Publication date	30/03/2015
Document Nr.	SUPAIR_2015/03_001
Number of page	1 / 4

SAFETY NOTE

TOPIC : WALIBI² and EVASION² reserve parachute handle extraction

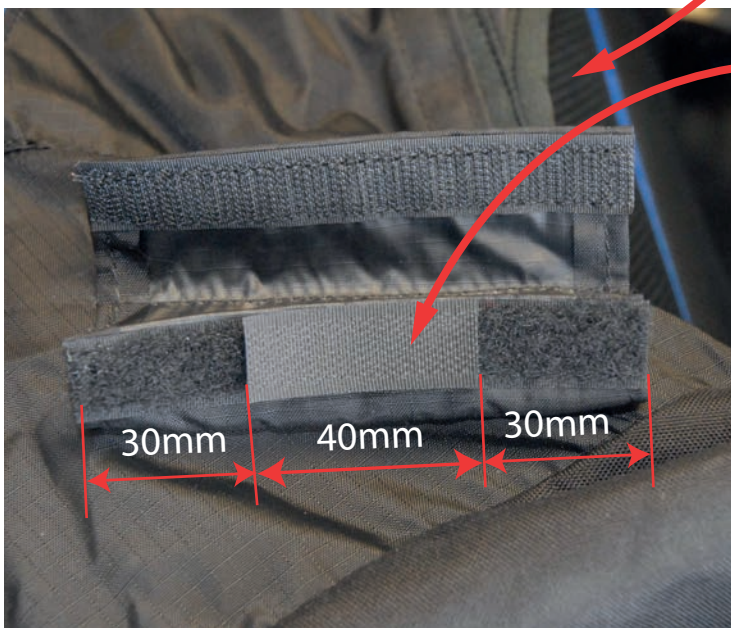
How to identify if my harness is concerned ?

The handle's housing Velcro is continuous and cover the entire width of the fabric

The handle's housing Velcro is not continuous and does not cover the entire width of the fabric

Conduct a reserve parachute handle extraction during a hang test

Problem extracting the handle

No problem extracting the handle

Reducing the Velcro lenght

Refer to the next page

Install the reserve parachute again, take care of your harness for peace of mind and happy flights !

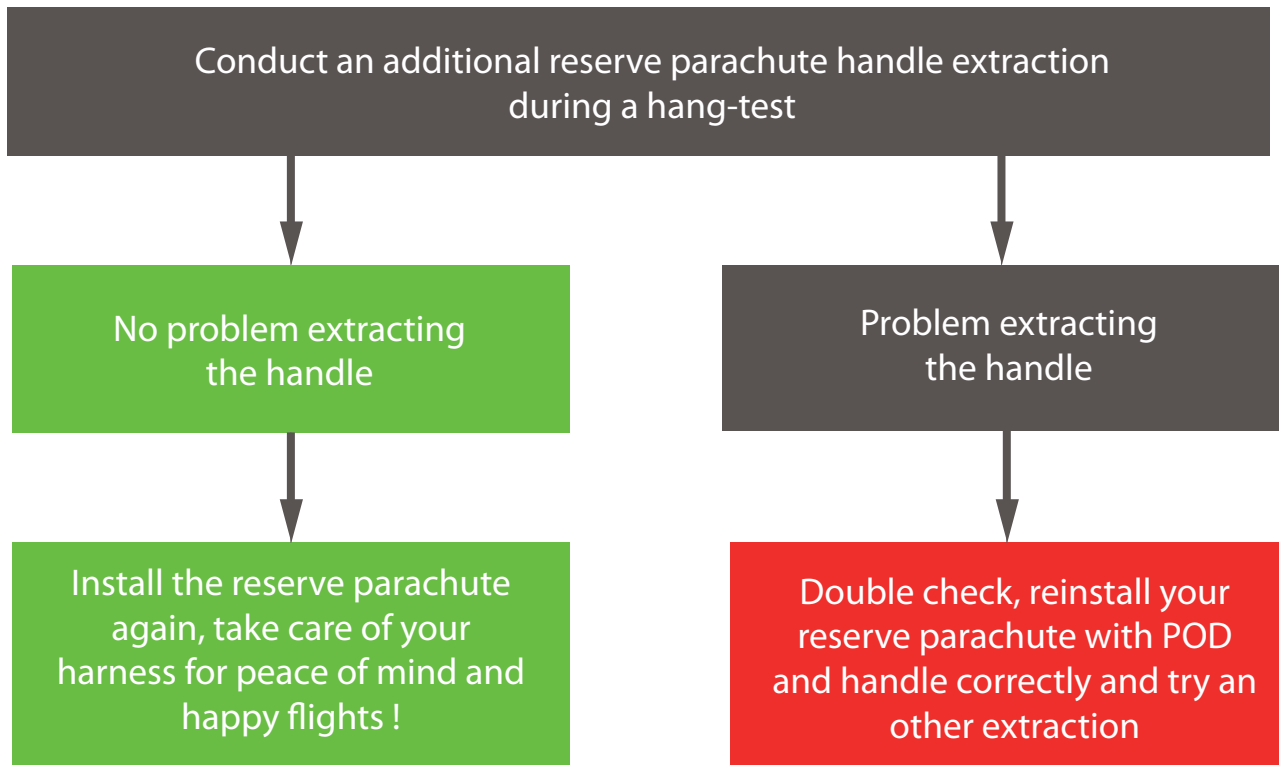
① Original handle housing arrangement

Open the handle housing :
the Velcro is continuous. ②

③ Solution :

Add and fasten a hook side Velcro strip 16mm wide x 4cm long to the middle of the handle's housing original Velcro.

This strip will neutralize a section of the Velcro where the handle connects, and hence facilitates the extraction sequence.
